San Francisquito Creek HEC-RAS Model Third-Party Peer Review February 2024 (SFCJ.01.23)

SAN FRANCISQUITO CREEK
JOINT POWERS AUTHORITY

Schaaf & Wheeler
4699 Old Ironsides Drive, Suite 350
Santa Clara, CA 95054

Figure 3-10: Comparison of Model Results Before (hatched blue) and After (solid red) Incorporating New Channel Survey

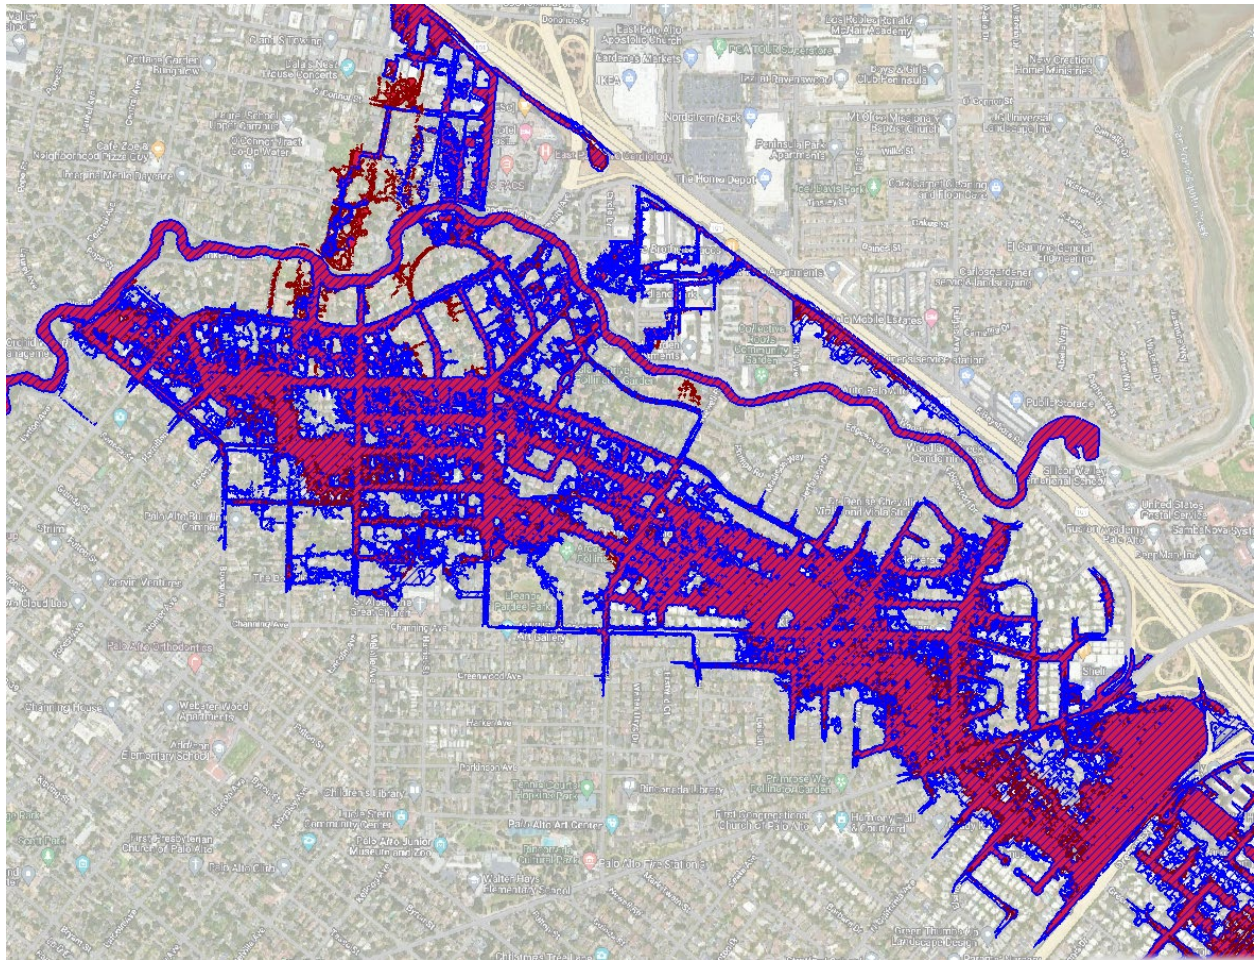
An “all else equal” comparison of two model scenario inundation extents is shown as Figure 3-10. The modeled scenarios both incorporate adjustments to roughness values in the creek and modifications made to the lateral structures and 2D areas to better represent bank conditions. One run is based on the original model cross sections and the other is modified with the updated Valley Water survey points.

Once the new survey data are incorporated into the model, the model shows greater spilling upstream of Pope/Chaucer bridge. This is likely due to a localized accretion of materials along the channel bed during the storm event compared to bed elevations that are based on prior surveys. Since the long-term channel bed profile is generally stable, this change may be more transitory and due to event-based sediment accretion. There also appears to be some minor reduction in spills to the north of the creek due to channel incision and widening just downstream (Figure 3-11). However, the overall impact of the survey is relatively small. Changes in the channel bed may have some impact on spill from the creek, at least during this approximately 30-year peak flood event.

Figure 3-13: Adjusted HEC-RAS Geometry NYE22 Model Results (maximum depth) with High Water Marks as Yellow Dots (Southwood Drive location shown as red dot)

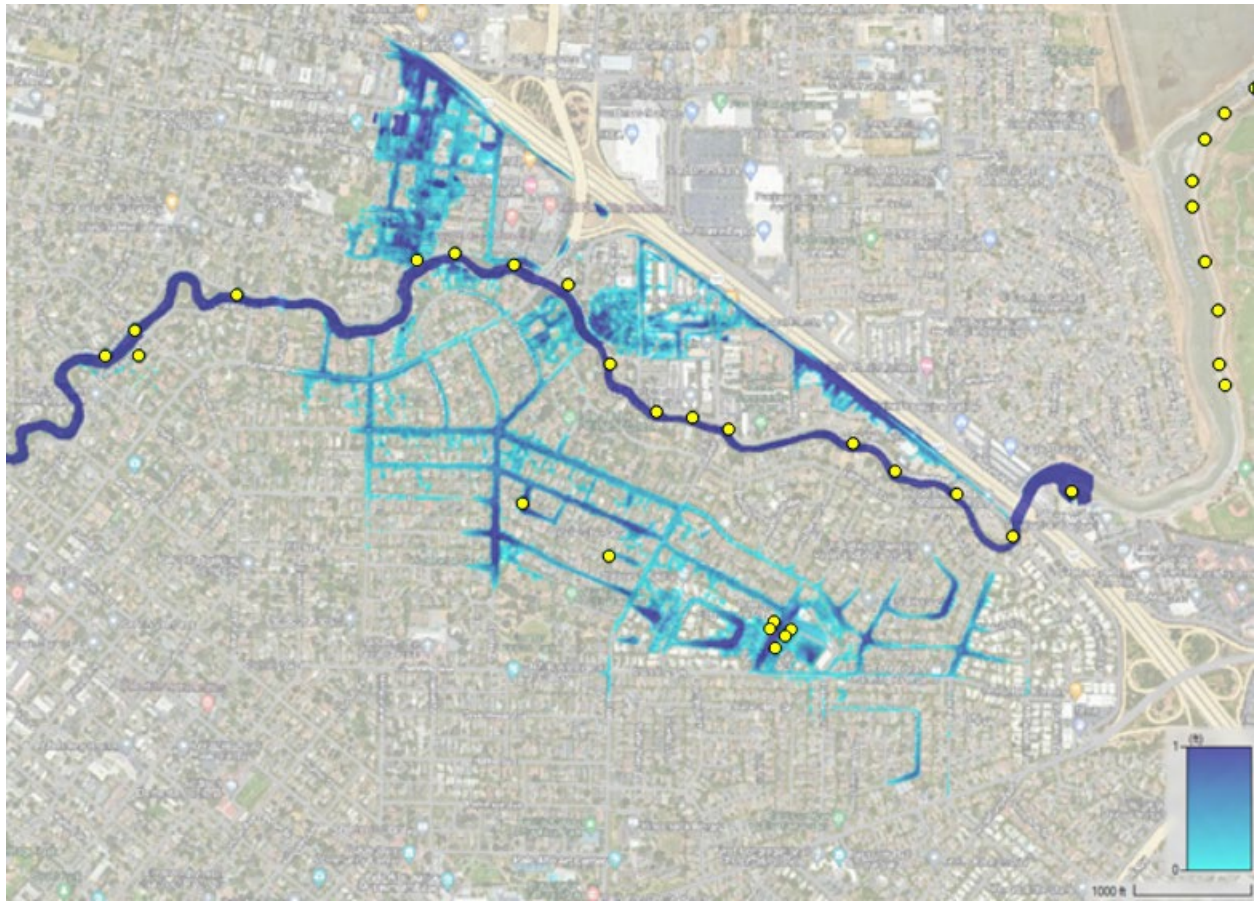
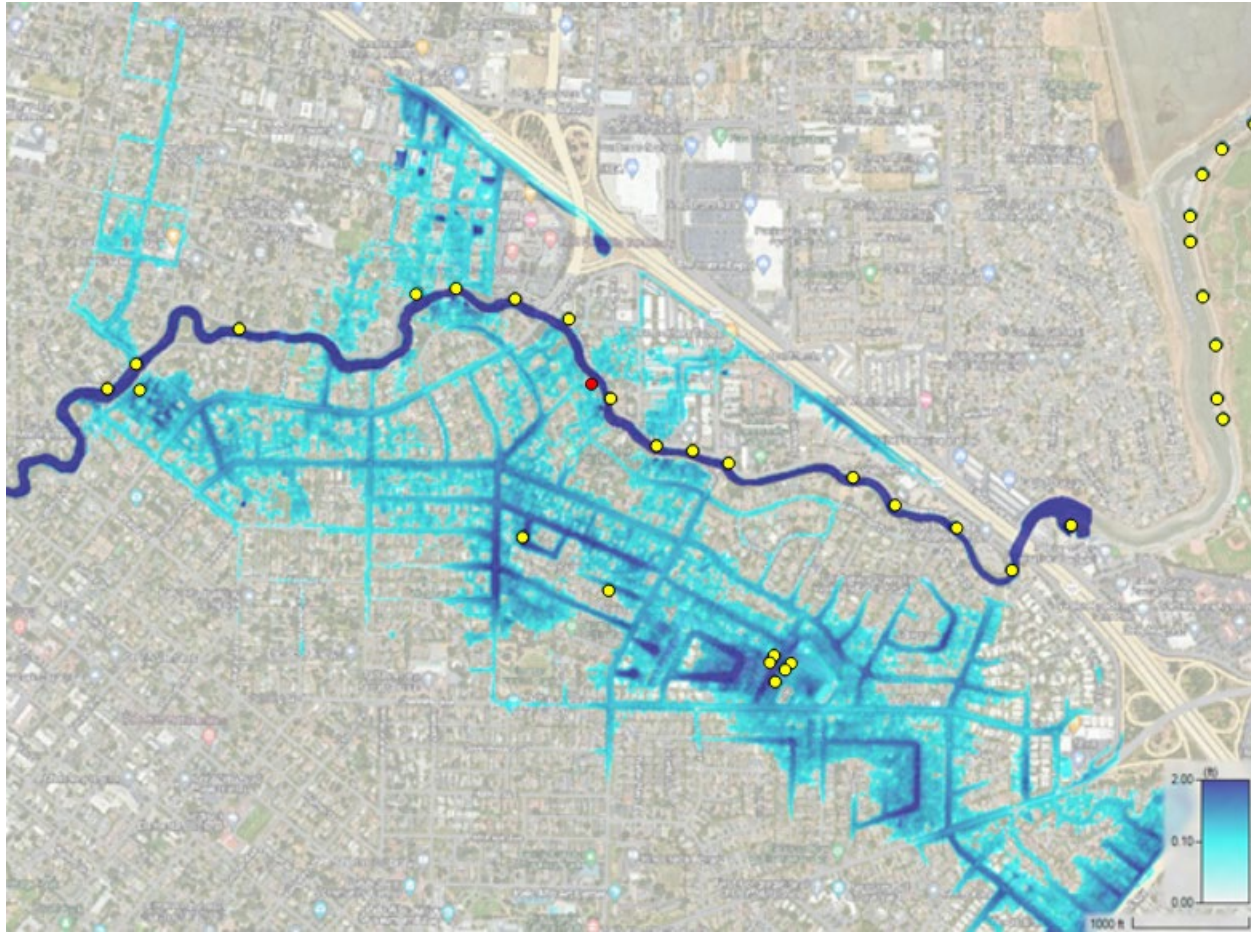
The maximum depths of overbanking of up to 12 inches produced by the Valley Water run calibrated to replicated flooding extents at Duveneck Elementary is shown in Figure 3-12. The maximum depths predicted by the adjusted HEC-RAS model are shown in Figure 3-13 and predict a greater flooding extent than the high-water marks (HWMs) indicated with yellow dots. Note that Figure 3-12 and Figure 3-13 show the results from the original Valley Water HEC-RAS model and the adjusted HEC-RAS model for the NYE22 event, respectively, and the effects of storm drain systems in East Palo Alto, Menlo Park, and Palo Alto are not included in either model.

Most of the observed high water marks away from the creek are within the right overbank floodplain on the Palo Alto side. City of Palo Alto Public Works staff noted that they did not observe a spill on the south side of the creek downstream of Southwood Drive, shown as a red dot in Figure 3-13. A small adjustment was made to right bank roughness through a 200-foot reach of the creek downstream of that location, illustrating the sensitivity of the model to roughness values. This could also be a reach that requires refinement of modeled lateral structure elevations to better reflect spills to the north and south. However, the model represents observed high water marks more closely with this final adjustment.

Figure 3-14: Final Adjusted HEC-RAS Geometry NYE22 Model Results (maximum depth) with South Bank Roughness Adjustment to Reduce Spill Downstream of Southwood Drive (red dot)

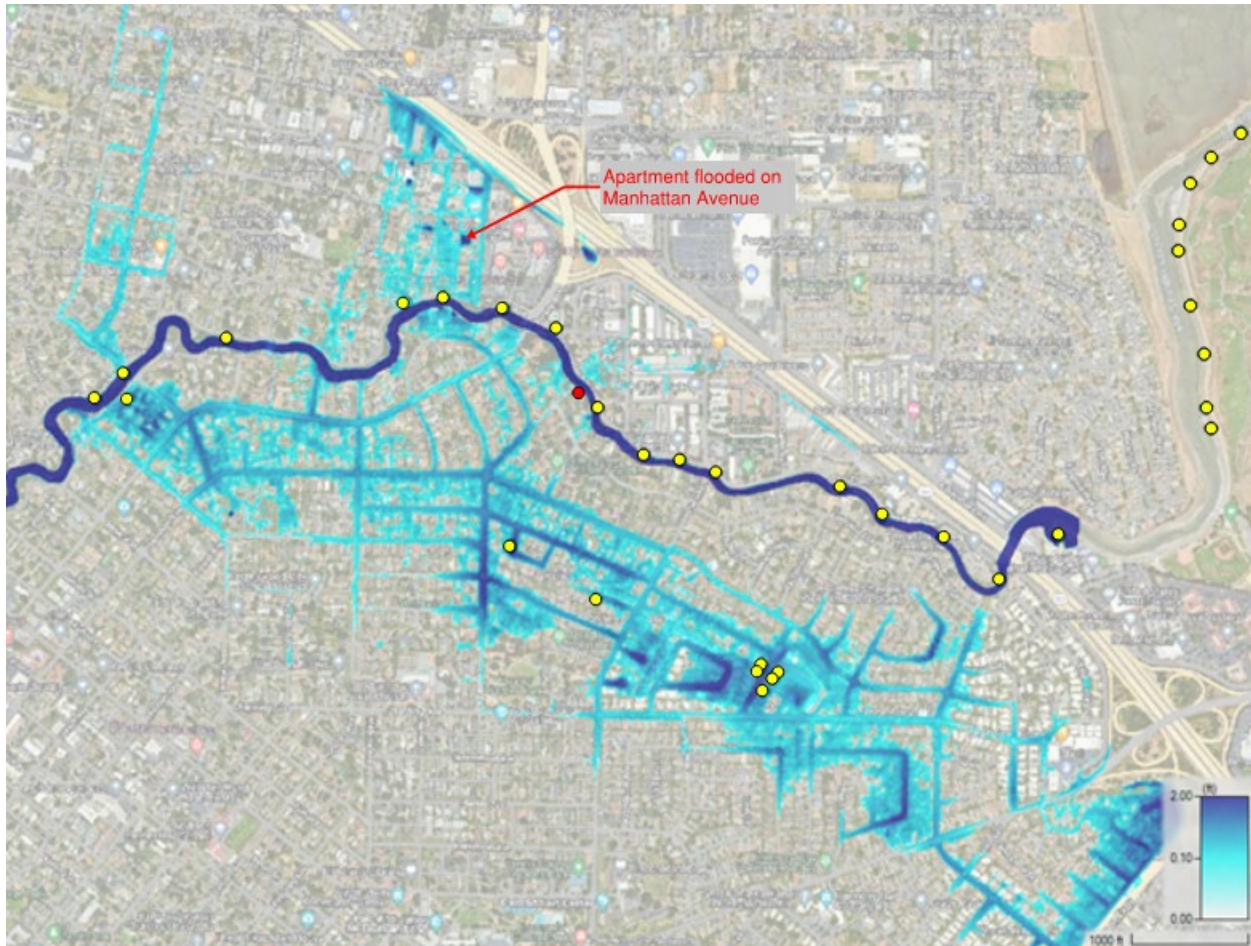
The result of the model run incorporating observations made in East Palo Alto, Menlo Park, and Palo Alto is shown in Figure 3-14. Note that these results are from the final adjusted HEC-RAS model and do not include the effects of local storm drain systems.

Figure 4-4: ICM Result with River Geometry Updated Based on the Final Adjusted HEC-RAS Model

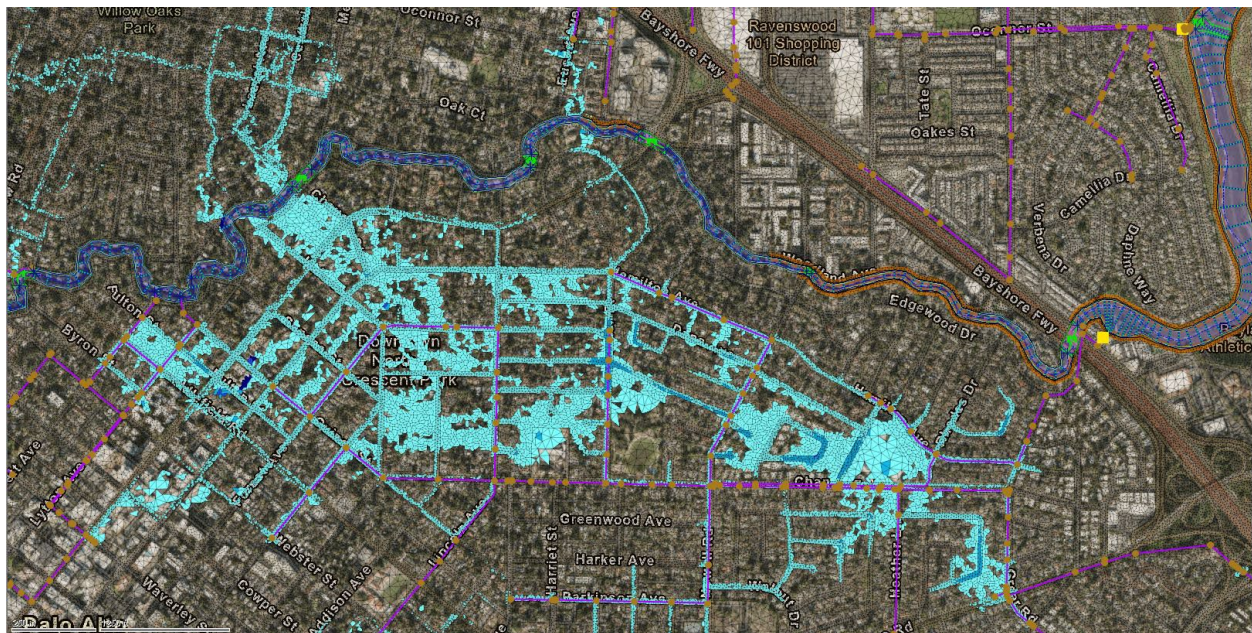
The ICM shows that with the adjustments to the RAS model described in Chapter 3 translated to the integrated cities-wide storm system model, urban flooding extents can be replicated when compared to estimated high-water marks provided by Valley Water and information provided by Menlo Park and Palo Alto.

The ICM uses the same creek geometry as the HEC-RAS model, but the models' calculation engines are different, so using identical creek geometry does not produce identical results. As shown in Figure 4-4, the ICM would require some further adjustment to reproduce the observed creek spill into East Palo Alto along Woodland Avenue east of Euclid Drive. For example, observed flooding of the apartment complex on Manhattan Avenue is not predicted by ICM. Based on the sensitivity of model overbanking to slight changes in model parameters, this could likely be achieved without significantly changing right bank overflows. However, since the intent of using ICM is to verify behavior away from the creek rather than to replace the HEC-RAS model, this additional effort has not been expended.

Figure 6-4: Bulletin 17B Analyses with a 200 cfs Low Outlier Threshold (top) and a 500 cfs Low Outlier Threshold (bottom)

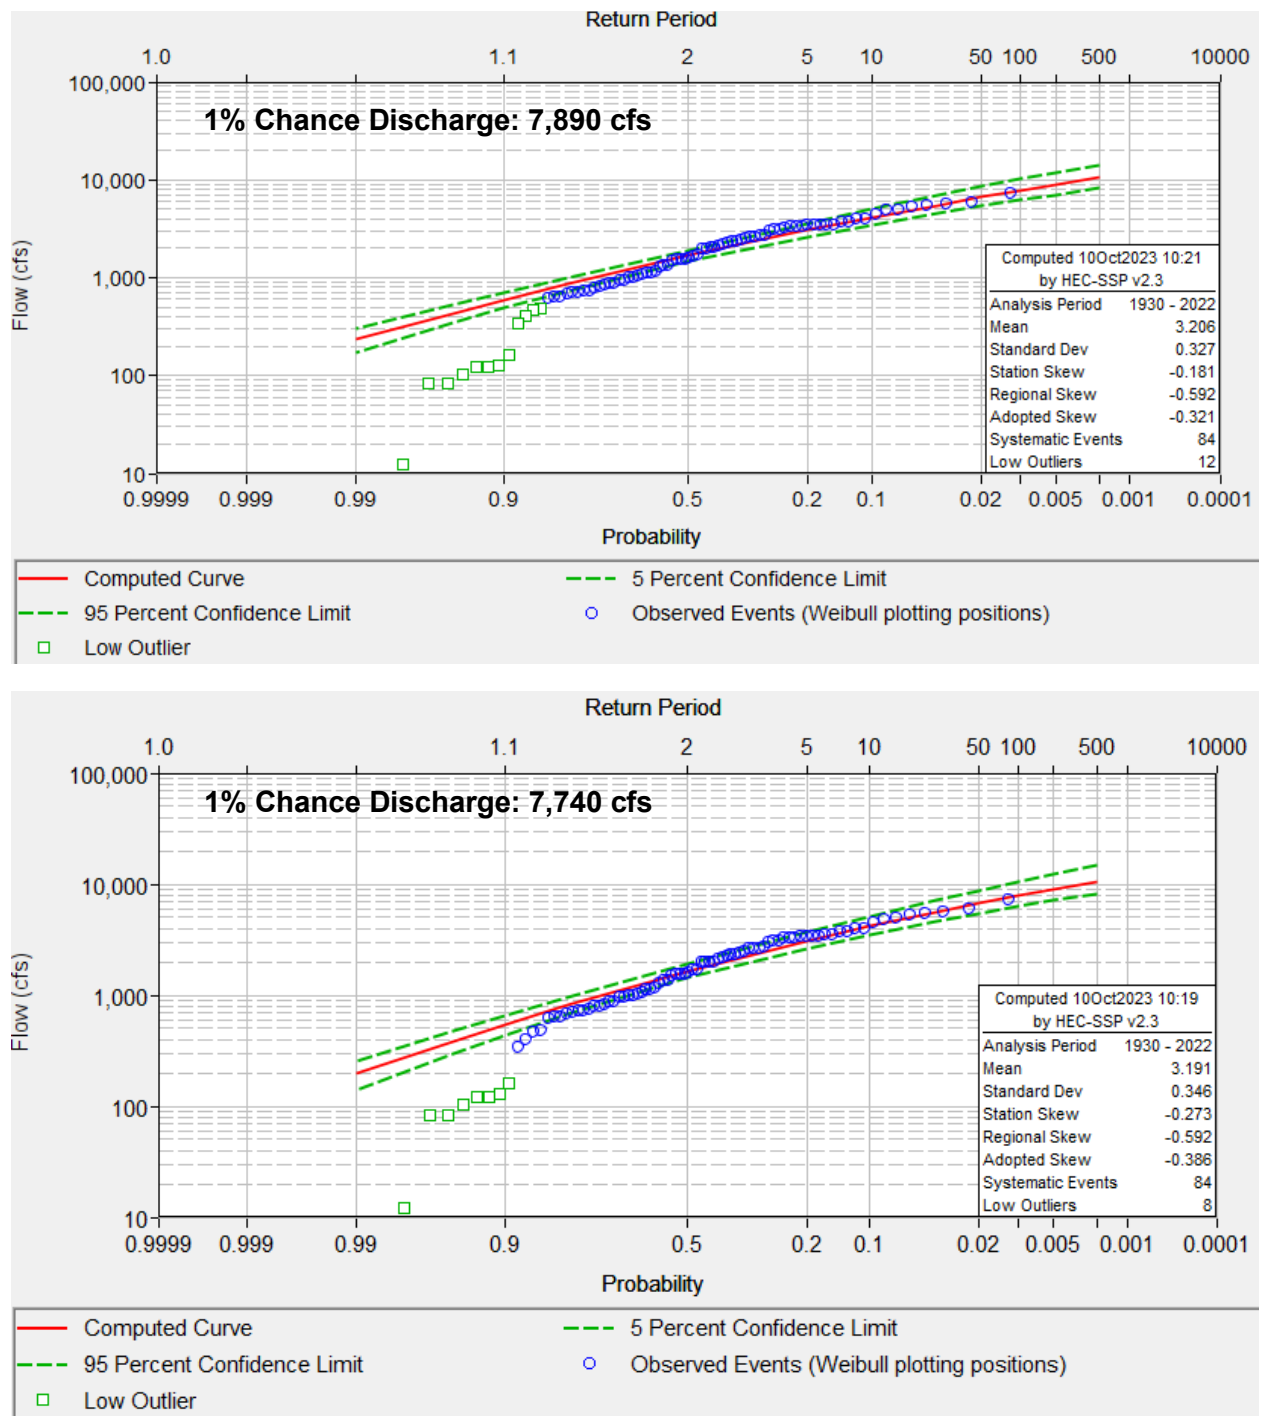
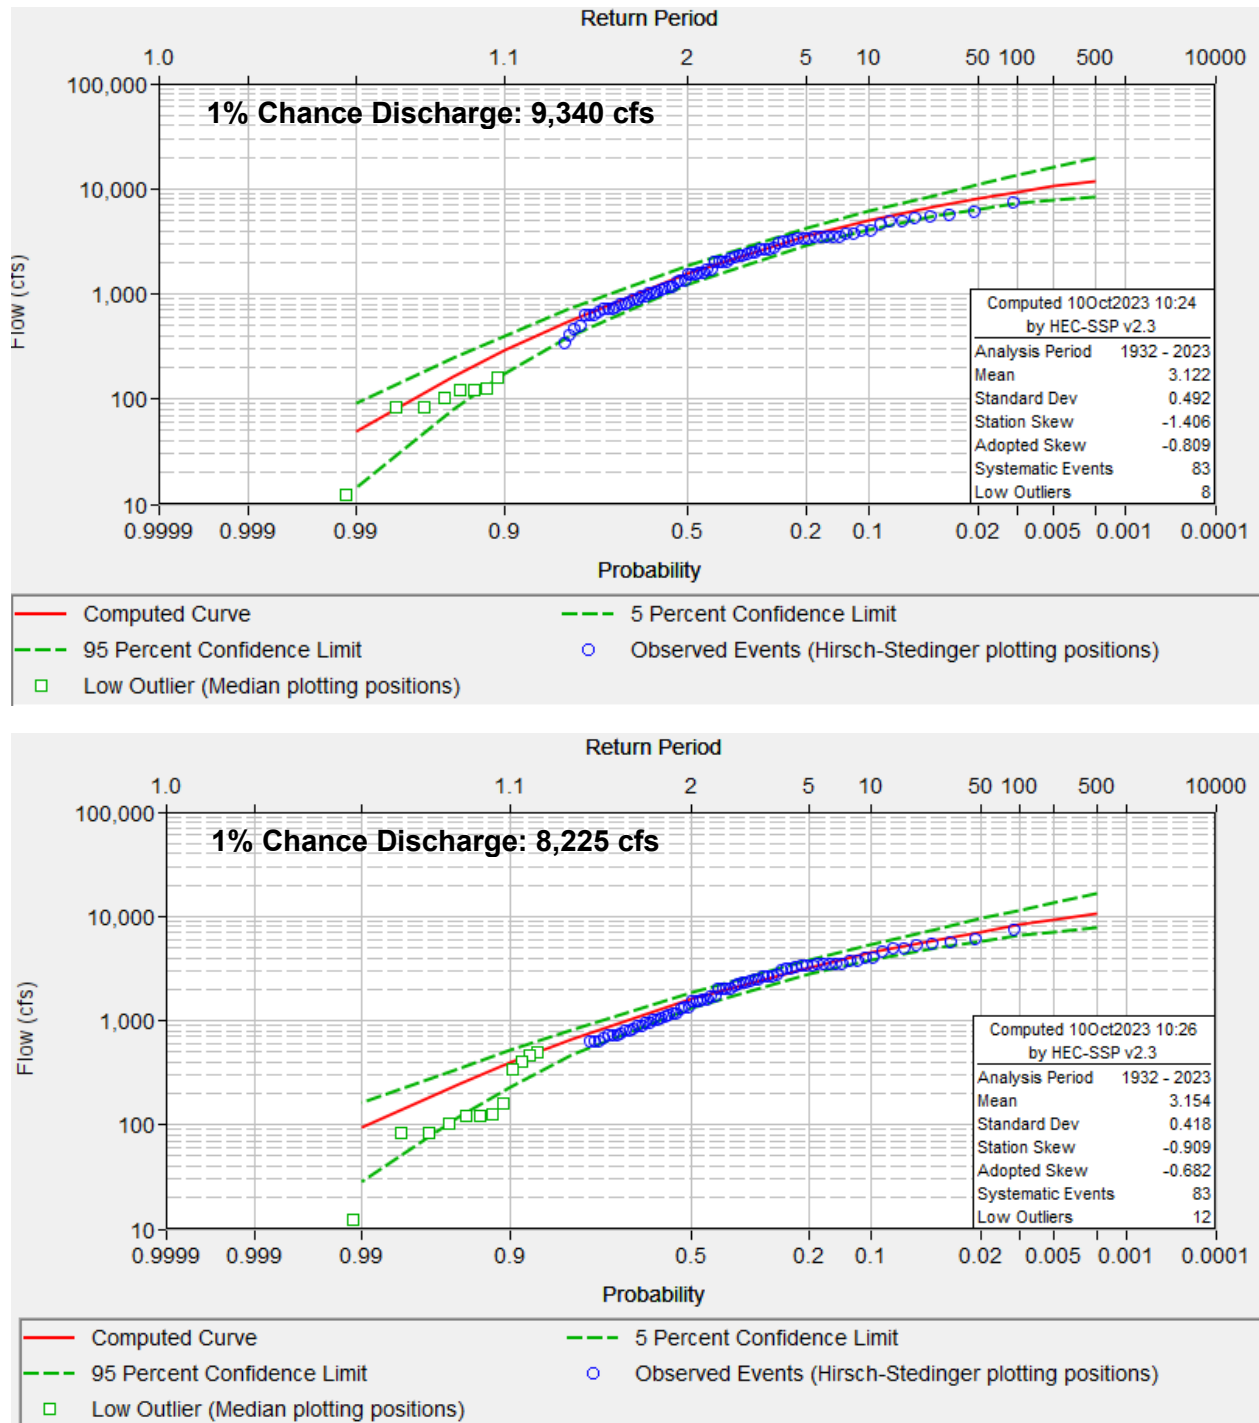
Starting with the Bulletin 17B methodology, the low outlier threshold is manually entered iteratively until the values used to generate the expected value curve do not fall significantly outside of the calculated confidence intervals. The results of the modified 17B analysis are shown in Figure 6-4. The same thresholds are then applied using Bulletin 17C methodology in Figure 6-5.

Bulletin 17C methodology is more sensitive to low outlier threshold adjustment than is using Bulletin 17B. A good choice for an initial low outlier threshold is 200 cfs, as those years stand out based on plotting position alone. However, that threshold produces an extreme result for the 100-year discharge, making it clear that there are still what the USGS refers to as “influential low floods” in the record. The second adjustment to 500 cfs removes those influential low flood events and produces a 100-year expected value close to the initial Bulletin 17C result presented in Figure 6-4.

The Bulletin 17B low outlier test is used to benchmark an appropriate adopted threshold. Based on the sensitivity analysis, this process begins with the removal of peak discharge values below 200 cfs. Then, additional years of record are removed until the low outlier test applied to the remaining values showed that they should not be removed from the record. With values below 200 cfs removed, the calculated 17B low outlier threshold is 205 cfs, indicating that it is appropriate to consider those values to be low outliers. With the next highest annual peak flow value (332 cfs) removed, the calculated low outlier threshold is 224 cfs, indicating that the 332 cfs peak value should remain in the record and included in the frequency analysis.
